Company Name:	MRMLLP	Site	Gulmohar Residency
Name of the customer	Mr. K. Prave		
Villa/ Flat No.	F-402		
Sl.No	Description	Amount	
1	Total extra Charges	31,740=00	
2	Total refundable amount	—	
3	Net amount to be charges (if any)	31,740=00	
4	Net amount to be refunded (if any)	—

Quality Control Check Report. Stage: After Finishing Stage III (Apartments)

F- Block 402, Modifications (CHECKLIST)

Details of Additions & Alterations

Changes in kitchen platform: (mark on plan)

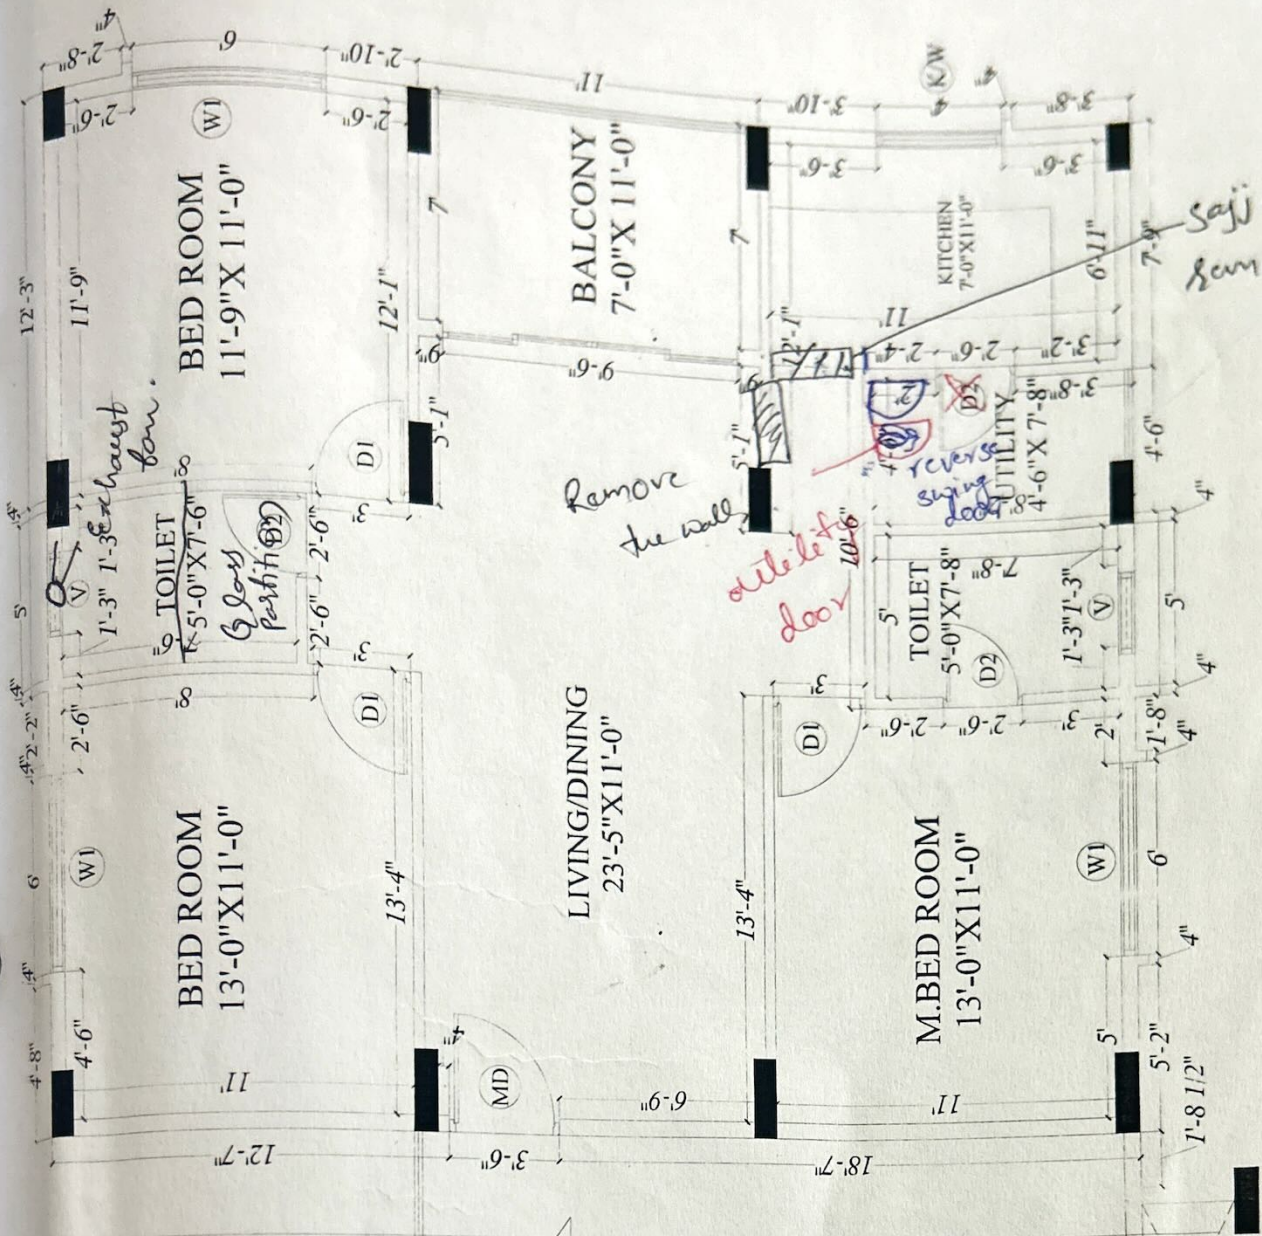
One extra plug point for water purifier
to height of the point from bottom
to 75"

Description		Direction	Owners & Developers :		Date	Promoted by
WORKING PLAN-1360 SR-A2 TYPE		N	Modi Reality Mallapur LLP		25.09.2020	Modi Properties Pvt Ltd
			Project Name & Phase		Prepared By	
					Approved By

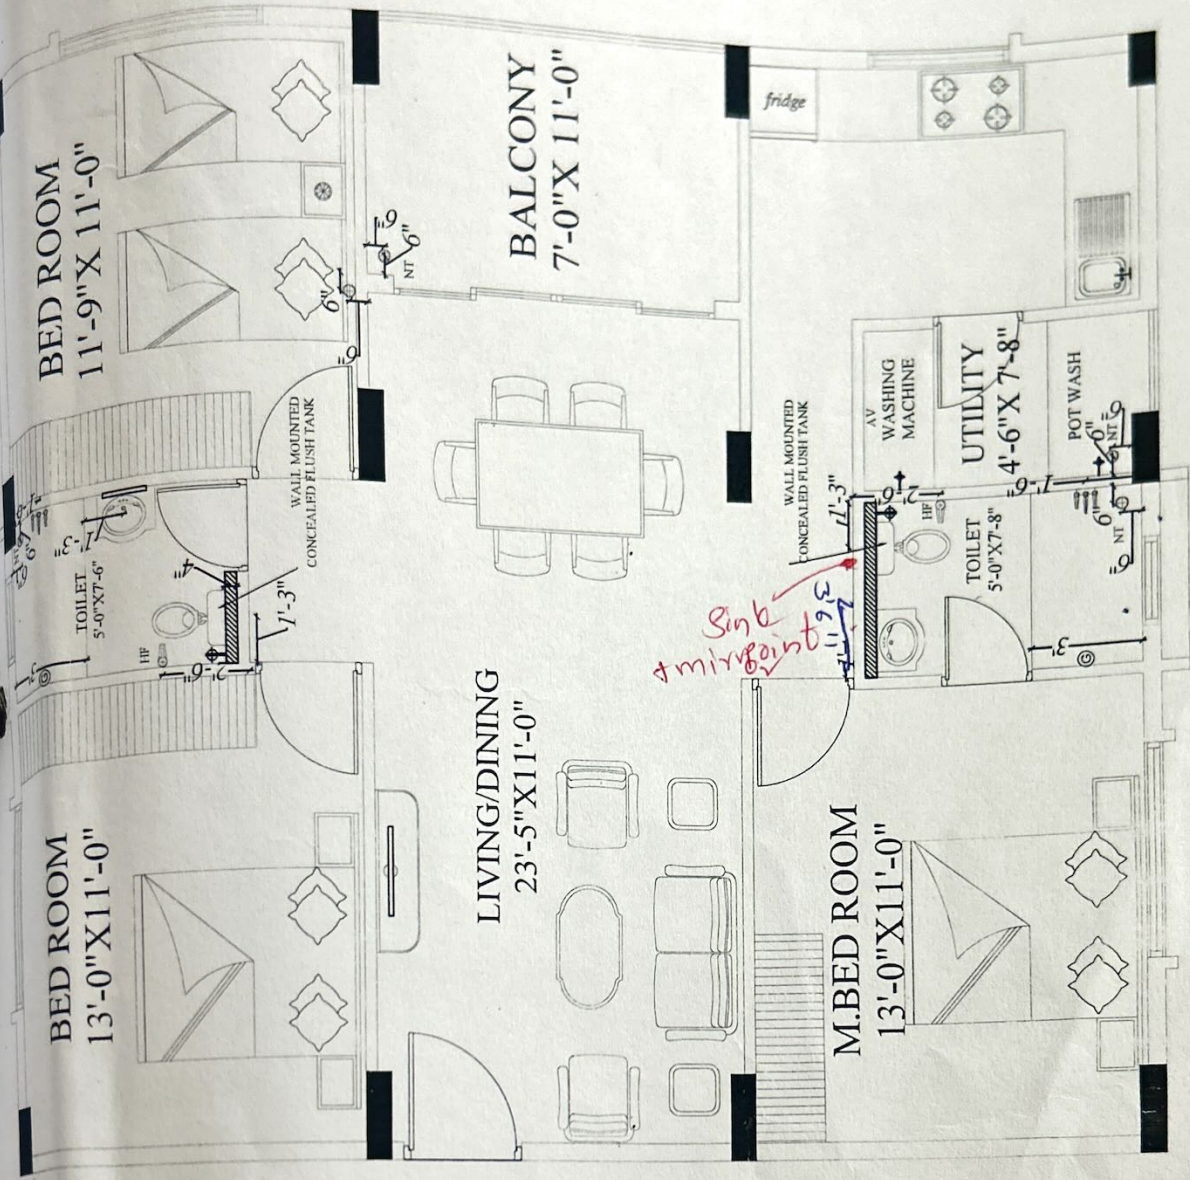
Two wash rooms
Glass partitions
(poly carbonate)
